# Recall Bulletin 170131REV

Fleetwood Brand:  
Model Year 2017  
Storm

Model Year 2016-  
2017 Vacationer  
manufactured  
9/23/15 - 11/3/16;

**SUBJECT:**  
Inspection/  
Correction of Fuel  
Fill Components

Figure 1

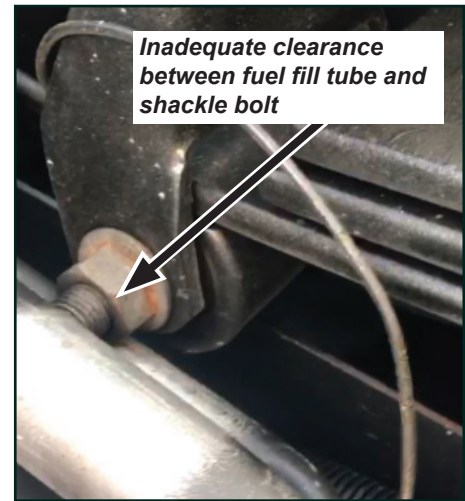
5. If any part of the fuel fill or vent tubing has 1/2" or less clearance from the spring shackle bolt (as shown in Figure 1), loosen the screws for the four clamps securing the EPDM rubber connectors located near the fuel fill. Remove any additional clamps or nylon ties securing the tubing between the fuel fill and the fuel tank.
6. a. Reposition the steel fuel fill and/or vent tubing further into the EPDM rubber connectors as needed to gain the proper (1/2" min.) clearance. (See Figures 2 and 3.) This may require some tugging or slight rotation of the tubing.

Figure 5

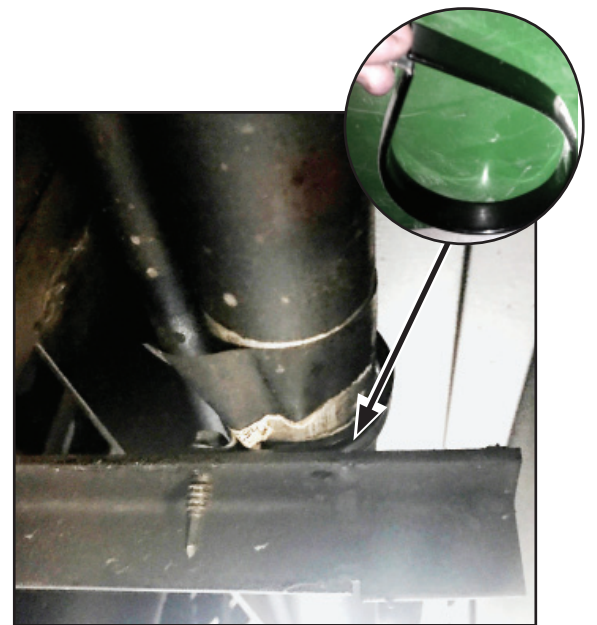
8. After proper clearance between the fuel fill and vent line and the spring shackle bolt has been achieved, secure the lines to the support bracket using an insulated clamp, REV Part # 10007781). Ensure the clamp goes around both tubes and is secured with a self-tapping screw to the support bracket. See Figure 5.

Insulated clamp secured with self-tapping screw
